**PLANNING DEPARTMENT ADMINISTRATIVE PUBLIC HEARING
SUMMIT COUNTY, UTAH
December 5, 2024**

- 1.A. **430 Deer Valley Loop Road – Administrative Conditional Use Permit** – The Applicant Proposes a 10-Foot Retaining Wall within the Side Setbacks in the Residential-Medium Density Zoning District. PL-24-06321.
(A) Public Hearing; (B) Action

Planning Department Staff Report

Subject: 430 Deer Valley Loop
Application: PL-24-06321
Author: Jacob Klopfenstein, Planner I
Date: December 5, 2024
Type of Item: Administrative Conditional Use Permit

Figure 2: Applicant's submittal (Exhibit B) showing proposed new concrete block retaining wall to replace the failing wood retaining wall in the rear of the structure at 430 Deer Valley Loop.

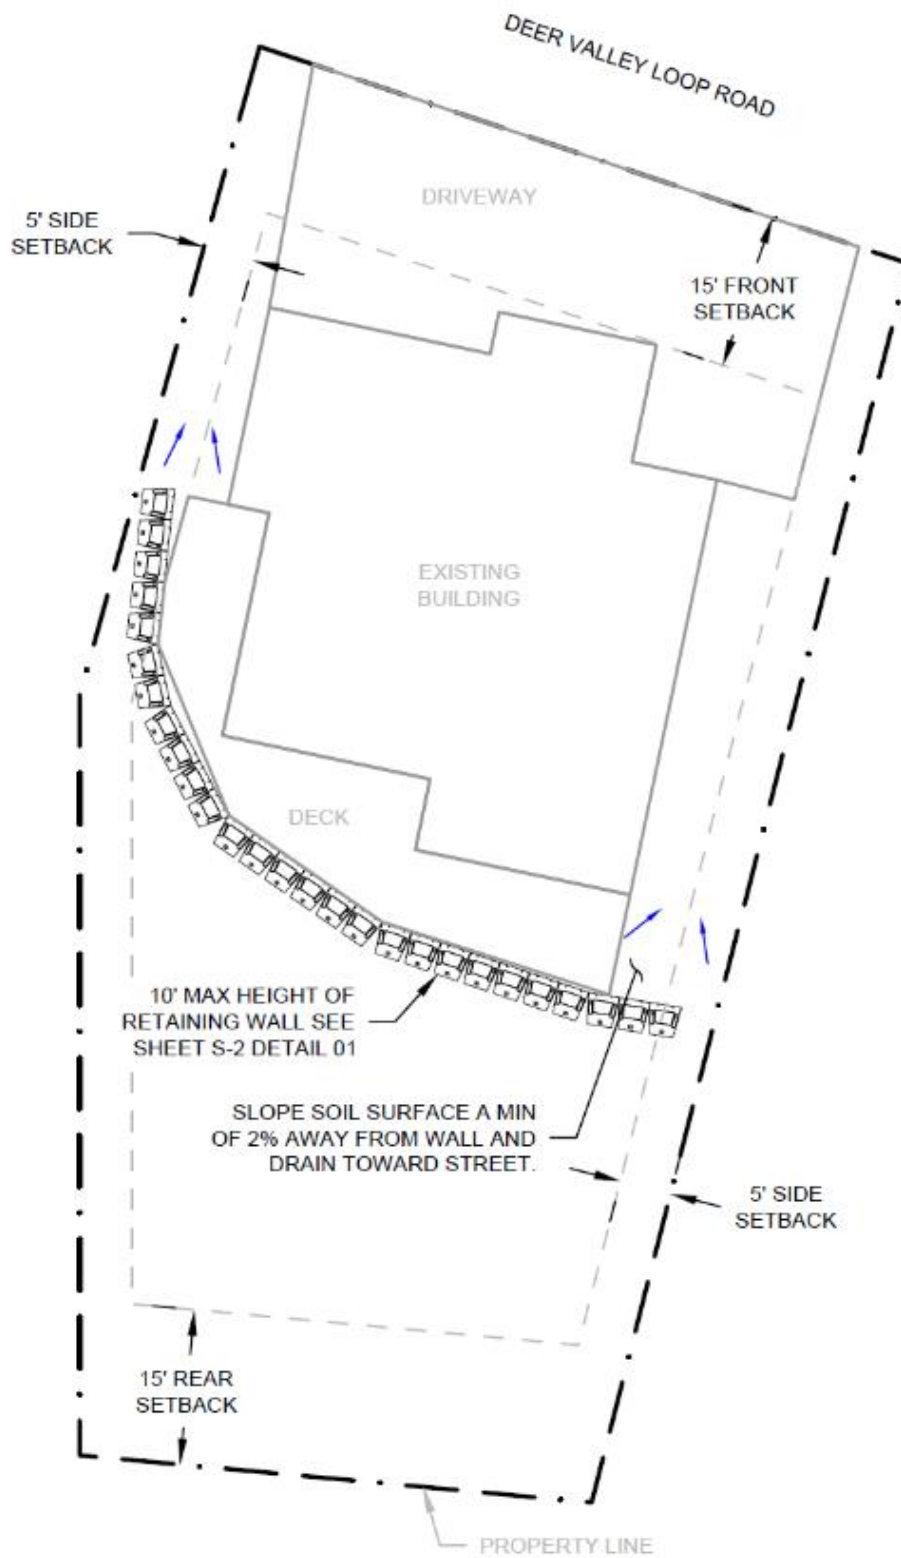
Rear Setback: 10 feet for SFDs	Complies: The proposed retaining wall is set back a minimum of 45 feet from the rear property line.
Side Setbacks: 5 feet for SFDs	Condition of Approval recommended: The proposed retaining wall is set back approximately six inches from the west side property line, and approximately three feet, six inches from the east side property line. Pursuant to LMC § 15-2.15-3(H), retaining walls not more than six feet in height from Final Grade are permitted within the Side Setback. Retaining walls exceeding six feet in height from Final Grade within the Side Setback require an ACUP. A retaining wall within the Side Setback may have multiple steps, but each exposed face cannot exceed six feet in height, and the horizontal distance between the walls from front face to rear face must be at least three feet and planted with approved vegetation. Condition of Approval 1 requires the Applicant to comply with this requirement. The proposed retaining wall includes stacked concrete blocks. Individual blocks are two feet in height. As shown in Figure 4, the stacked blocks are offset by about two horizontal inches, creating the effect of a single uniform wall without multiple steps and faces.

The proposed retaining wall includes a 4-inch perforated drainpipe below the bottom tier to provide drainage at both ends of the wall. Staff recommends Condition of Approval 3 requiring that drainage behind the new retaining wall be maintained such that water drains away from the walls to abate retaining wall failure and that all drainage is captured on the site.

1. Any portion of the proposed retaining wall that is within the Side Setbacks may have multiple steps, but each exposed face shall not exceed six feet in height, and the horizontal distance between the walls from front face to rear face shall be at least three feet and planted with approved vegetation.

3. Drainage behind the new retaining wall shall be maintained such that water drains away from the wall in order to abate retaining wall failure, and all drainage shall be captured on site. The Applicant shall verify drainage plans for the proposed wall with the Engineering Department during the Building Permit phase to ensure there is sufficient drainage for the proposed wall.
